REF: SUP-7002-23
DATE: September 14, 2023

Request	-	Special Use Permit for a School
Location	-	6004 Hill Avenue
Applicant	-	Ali Nawras 5957 Forest Hills Drive Maumee, OH 43537
Owner	-	Jaafary Islamic Center 6004 Hill Avenue Toledo, OH 43615
Architect	-	Benchmark Engineering Group Inc. 3161 N. Republic Boulevard Toledo, OH 43615

The staff recommends that the Toledo City Plan Commission recommend approval of SUP-7002-23, a request for a Special Use Permit for a School located at 6004 Hill Avenue, to the Toledo City Council, for the following **two (2) reasons**:

COVER SHEET & SITE PLAN

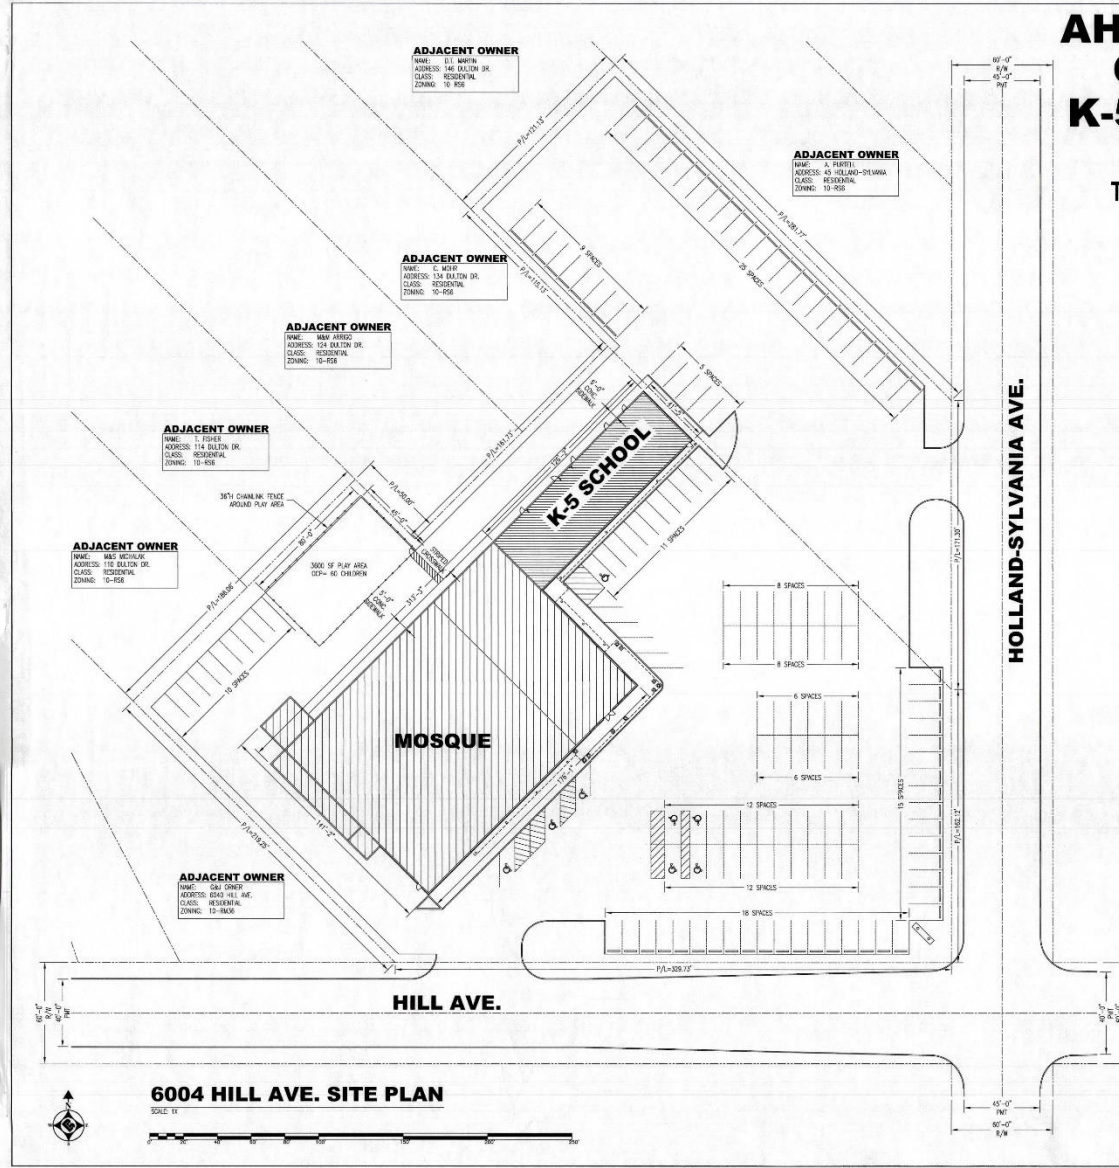
In addition to that, thirty-nine (39) parking spaces are provided at the adjacent property at 41 N. Holland-Sylvania Road owned by the applicant. The site plan does not show any bicycle parking spaces. Twenty-six (26) bicycle spaces are required for the school. This shall be shown on a revised site plan.

21. Per **TMC§1107.0304** one (1) space paved off-street area for dropping off and picking up students at the school must be provided **Not acceptable as depicted. Drop-off and pick-up space shall be shown on a revised site plan.**

22. Per **TMC§1107.0900**, twenty-six (26) bike parking spaces are required. **Not acceptable as depicted. Bike parking spaces shall be shown on a revised site plan.**

- a. A five-foot (5') greenbelt is required along the property line fronting Hill Avenue and Holland-Sylvania Road. The frontage greenbelt shall include a solid evergreen hedge to screen parking in the front of the property and prevent headlights from being seen from the right-of-way. **Not acceptable as depicted on site plan. Applicant shall submit a landscaping plan showing the greenbelt buffer;**

- b. **TMC§1108.0204(B)(9)** requires perimeter landscaping to be installed along any parking lot area adjacent to a street, place, or driveway, or which is visible from an immediately adjacent property, and must include a continuous shrub row with a minimum height eighteen inches (18"). Perimeter landscaping must consist of a landscape area at least 10 feet in width, exclusive of sidewalks, walkways, trails, or right-of-way and must be located between the parking lot and the property line. **Not acceptable as depicted. Applicant shall submit a landscaping plan showing perimeter landscaping along the north and west property lines;**
